**Safety Evaluation Report
License Amendment for the Ludeman Project to the
Willow Creek In Situ Recovery Project
Converse County, Wyoming**

Materials License No. SUA-1341

URANIUM ONE USA CORPORATION

Figure 2.4-3 Surface Water Features and Rights near Wellfields 1 and 2

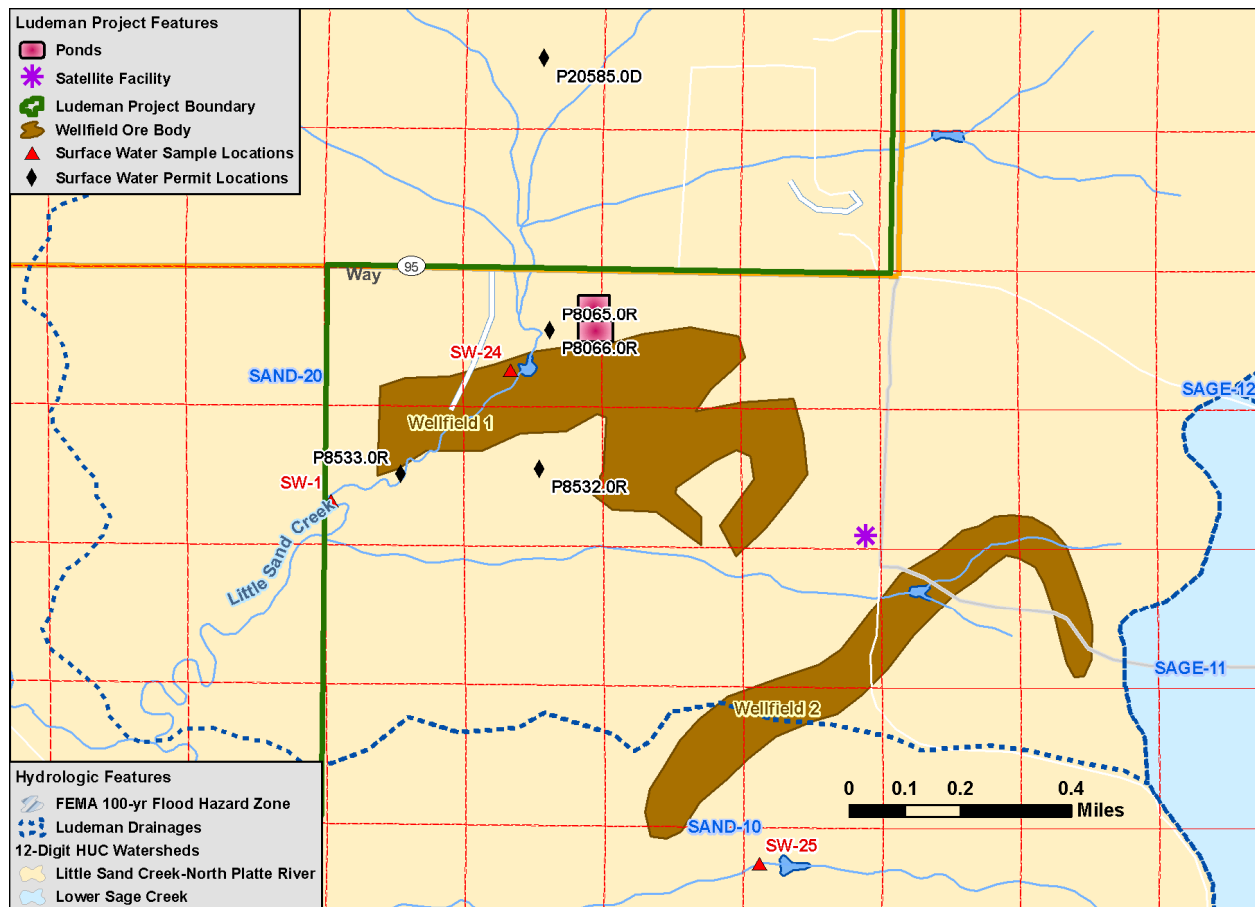
The NRC staff reviewed the FEMA 100-year flood hazards, surface water rights and sampling locations on a wellfield by wellfield basis. The surface water features near the Ludeman satellite facility and Wellfields 1 and 2 are shown in SER Figure 2.4-3. The satellite facility and both wellfields are located in the Sand -20 drainage of the Little Sand Creek sub-watershed. The southern tip of Wellfield 2 is located in the Sand -10 drainage. No FEMA 100-year flood hazard zones are present within or near the satellite facility or these wellfields.

The licensee reported there were five surface water rights within 2 km of Wellfield 1 and 2 as shown in SER Figure 2.4-3. The NRC staff reviewed the status of these surface water rights using the Wyoming State Engineers Office (WSEO) water rights database. The NRC staff found two of the surface water rights, P8065R and P8066R, were for two evaporation ponds used for liquid waste disposal at the historical Teton Pilot ISL. The historical location of the two ponds has been noted by the NRC staff on SER Figure 2.4-3 based on drawings from original 1983 Leuenberger Final Environmental Impact Statement (FEIS) (NRC 1983). The NRC staff determined that both of these ponds were decommissioned before the Teton Pilot ISL license was terminated (NRC 1986). In addition, the WSEO permits have been cancelled. Two other permits for impoundments, P8533.0R and P8532.0R, were also issued for the historical Teton ISL facility. The NRC staff determined these impoundments were never built and the WSEO permits were cancelled. The remaining surface water permit, P20858.OD, was issued in 1951 for storage of irrigation water and has expired. The NRC staff therefore finds there are no current surface water rights within 2 km of Wellfields 1 and 2.

The licensee reported it had located three surface water sampling points (SW-1, SW-24 and SW-25) near Wellfields 1 and 2. These locations were sampled to evaluate surface water quality before operations. A discussion of pre-operational water quality measured at these locations is provided separately in SER Section 2.5.3.1.

Figure 2.4-5 Surface Water Features and Rights near Wellfields 5 and 6

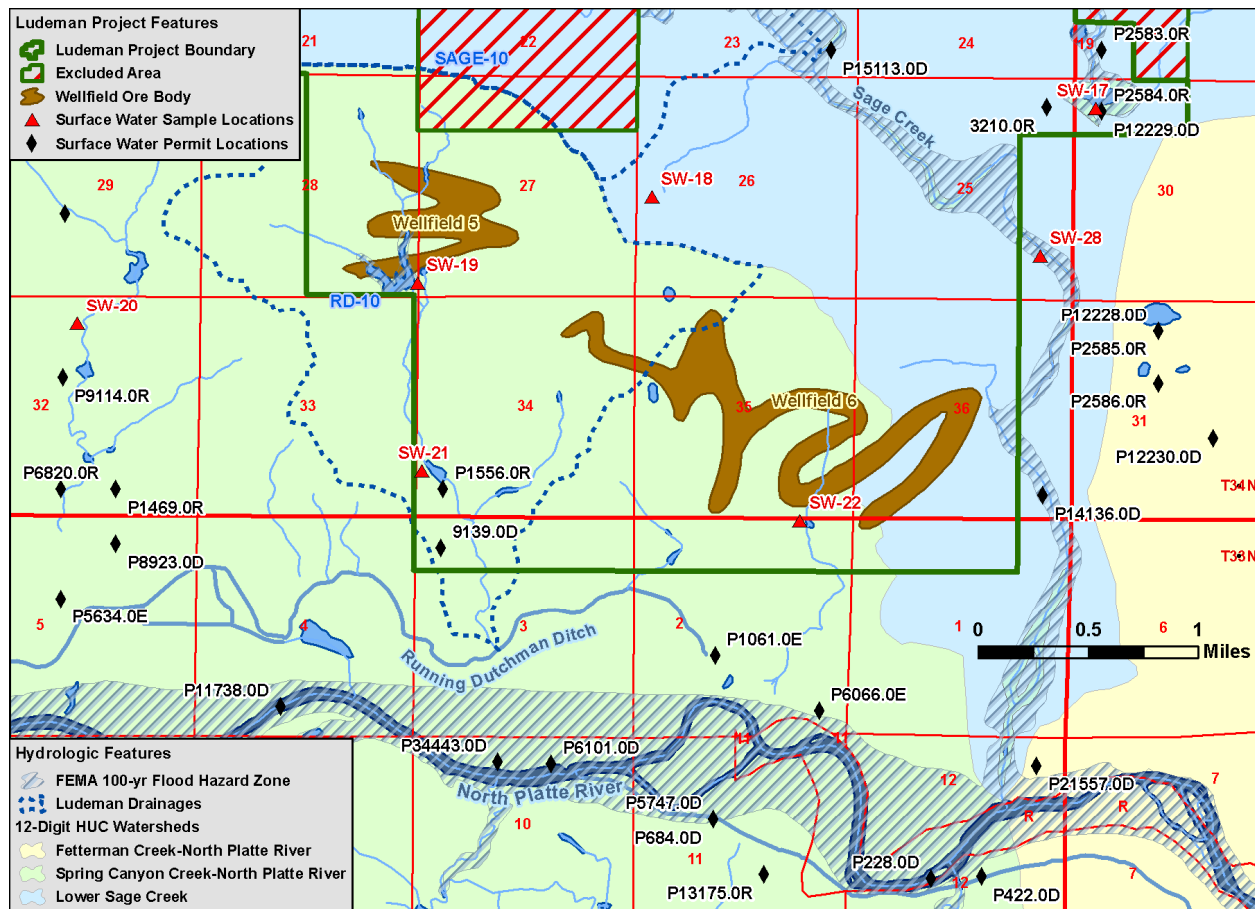
The surface water features for Wellfield 5 and 6 are shown in SER Figure 2.4-5. Wellfield 5 is located in RD -10 sub-watershed. Wellfield 6 is located in far eastern portion of RD-10 and the Lower Sage Creek watershed. Sage Creek to the east and the North Platte River to the south display FEMA- 100 year flood hazard zones all along their length. One impoundment to the east, known as Gilbert Lake, is shown as a 100- year flood hazard zone. The NRC staff finds these 100- year flood hazard zones are located sufficiently distant from Wellfield 5 and 6 and are unlikely to be a significant source of flooding.

Another large impoundment, located in Wellfield 5 in Section 28 of T34N R73W, is marked as a FEMA 100- year flood hazard zone in SER Figure 2.4-5. The licensee identified this impoundment as WB-43 in Photo 23 of Addendum 3.5- K of the Ludeman Project Revised Environmental Report (Uranium One USA 2017e). The photo shows that WB-43 was inundated in August 2008. The licensee reported that WB-43 was a diked drainage, 5.09 acres in size, in the wetland summary table in Addendum 3.5-I of the Ludeman Project Revised Environmental Report (Uranium One USA 2017e). The NRC staff reviewed this information and recent satellite images of this impoundment in Wellfield 5 from 2009-2015. The NRC staff found the area of surface water feature was variable but it was inundated in different seasons over this time period.

10.23	3.1.4	<u>The licensee will not install any wells or wellfield infrastructure in Ludeman Project Wellfield 5 within the boundary of the surface water impoundment located in Section 28 of T34N R73W as shown in Figure 2.7A-1 of Addendum 2.7-A of the Ludeman Project Revised Technical Report.</u>

The NRC staff concludes that any wellfield infrastructure located in the footprint of this apparently perennial but variable surface water feature in Wellfield 5 would be subject to damage from periods of standing water and flooding. The NRC staff addresses the safety issues involved with this surface water feature in SER Section 3.1.3.8. Because of the safety concerns with this feature in Wellfield 5, the NRC staff will require new License Condition 10.23 to be added to the Willow Creek Source Materials License as described in SER Section 3.1.4 and shown in SER Table 1.1-1.

Figure 2.4-7 Ground Water Rights and Private Wells within 2 km of Wellfields 1 and 2.

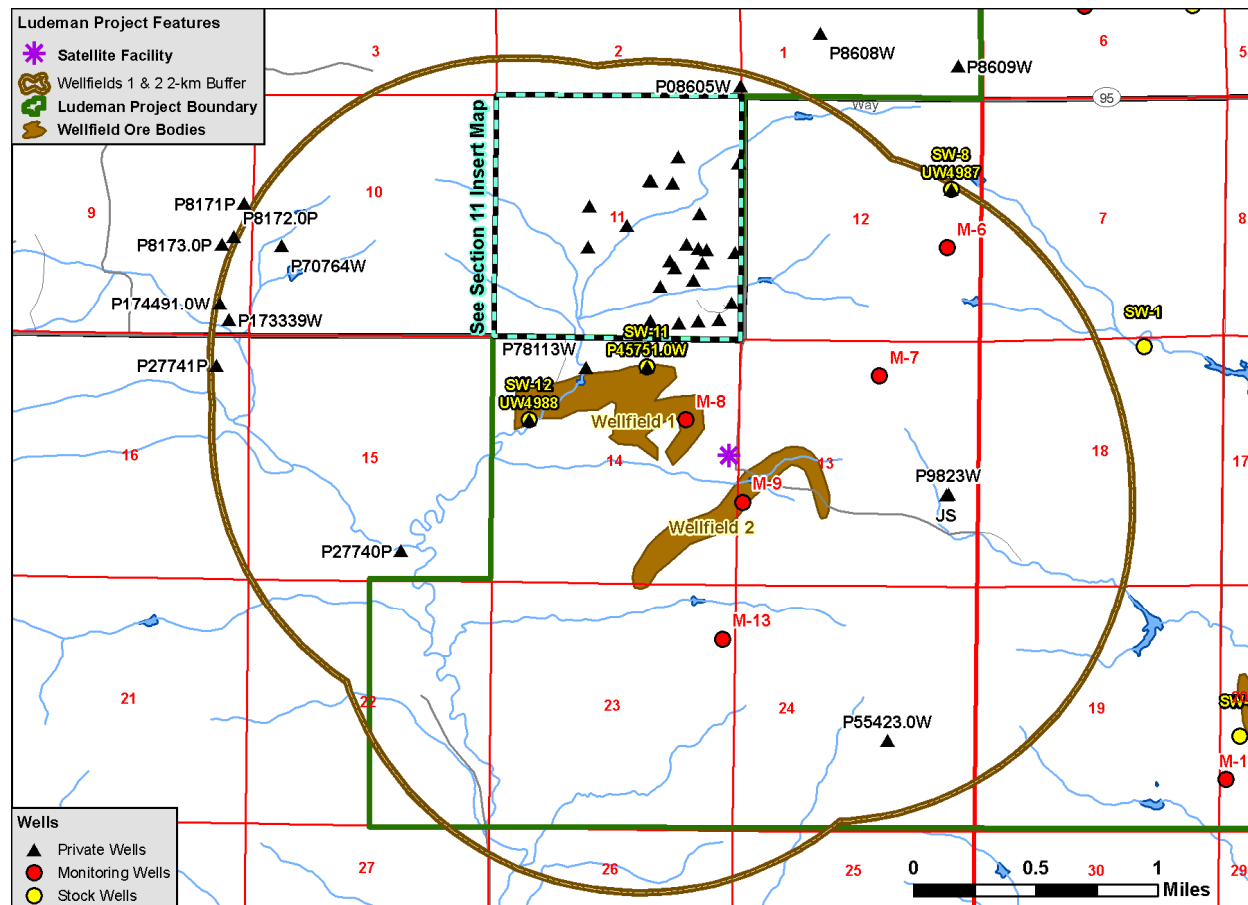
The NRC staff found only one domestic well, P9823W, identified by the licensee as the JS Well, was located in the license area at an estimated distance of 5475 ft from Wellfield 1. The licensee reported this well is currently associated with a residence and used for domestic purposes. The NRC staff reviewed the WSEO permit for the well, P9823W, and found it is reported as deepened to 160-180 ft. The NRC staff located the closest boring log (3473-18-1004) to this well on Cross Section C-C' in Figure 2.6A-7 of Addendum 2.6-A of the Ludeman Project Revised Technical Report (Uranium One USA 2017d). At this location and depth, Cross Section C-C' indicates the well is most likely completed in the 110 or 100 sand which overlies the 90 and 80 sand ore zones in Wellfield 1.

Other permits listed in SER Table 2.4-10 were for stock, irrigation, miscellaneous or industrial wells. Three of these wells, P4988 (SW-12), P45751.0W (SW-11) and P78113W were located within the footprint of Wellfield 1. The NRC staff compared the depth and location of these wells to Cross Section O-O' in Figure 2.6A-19 of Addendum 2.6-A of the Ludeman Project Revised Technical Report (Uranium One USA, 2017d). NRC staff concluded that Well P4988 (SW-12) is located in the 100 sand and Well P4751.0W (SW-11) is completed in the 110 sand, above the 90 and 80 sand aquifers. The licensee reported that the well P78113W was in the 60 sand below the targeted 90 and 80 ore sand aquifers.

The licensee reported and the NRC staff found many of the private wells in Negley Subdivision are located close to Wellfield 1 as shown in SER Figure 2.4-7. The NRC staff estimated the distance of these wells to the nearest Wellfield 1 boundary as shown in SER Table 2.4-11. The closest wells, N-2, N-19, N-12 and N-16, which are all domestic, are located less than 1500 ft from the boundary of Wellfield 1.

Figure 2.4-10 Ground Water Rights and Private Wells within 2 km of Wellfield 4

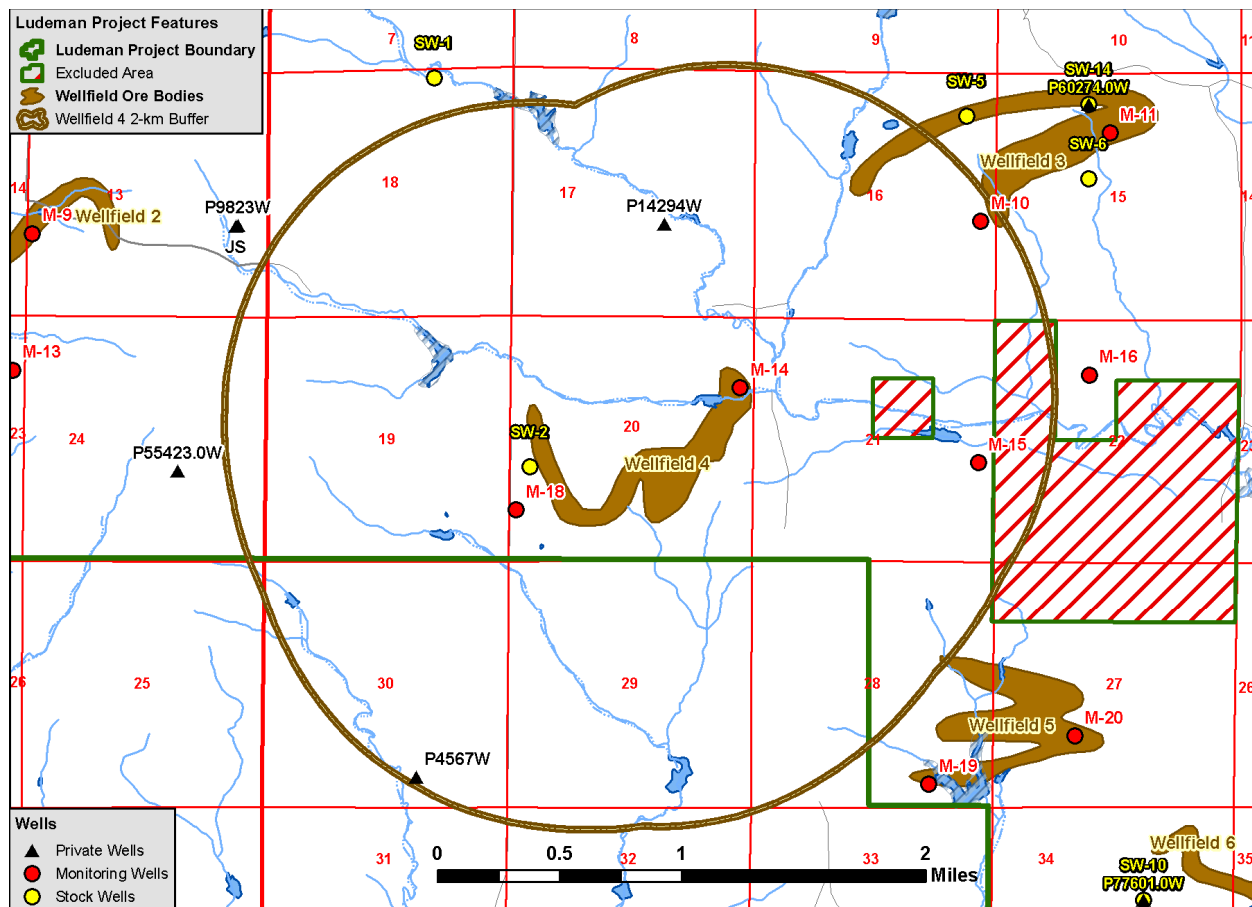
Wellfield 4 is located in T34N, R73W Section 20 of the license area. Figure 2.4-10 shows that there is one additional ground water right within 2 km of Wellfield 4 and one it shares with Wellfield 3. The licensee reported and the NRC staff verified all of the water rights are for stock or miscellaneous use. The ground water rights, well name, well completion information, and permitted use within 2 km of Wellfield 3 and 4 are shown in SER Table 2.4-13.

The Wellfield 4 ore zone is also located in the 70 sand aquifer. Based on values reported in SER Table 2.4-6, the 70 sand is located at a depth of 455 and 341 ft in Wells M-14 and M-18, respectively, completed in Wellfield 4. Well P4567W, with a depth of 265 ft bgs, was located almost 2 km away from Wellfield 3 outside the license area. The closest Cross Section I-I' in Figure 2.6A-13 of Addendum 2.6-A of the Ludeman Project Revised Technical Report (Uranium One USA 2017d), would suggest it is completed in the 80 sand which overlies the 70 production sand.

The NRC staff finds, however, the licensee has not committed to plug and abandon private wells that are in the production ore zone aquifer of any wellfield in the Ludeman Project Revised Technical Report (Uranium One USA 2017d). Therefore, the NRC staff will issue a new License Condition 10.26 for the Willow Creek Source Material License SUA-1341 that will state that the licensee will plug and abandon all private wells completed within the production ore zone aquifer within 500 ft of the perimeter excursion monitoring well ring as described in SER Section 5.7.8.3.1 and shown in SER Table 1.1-1.
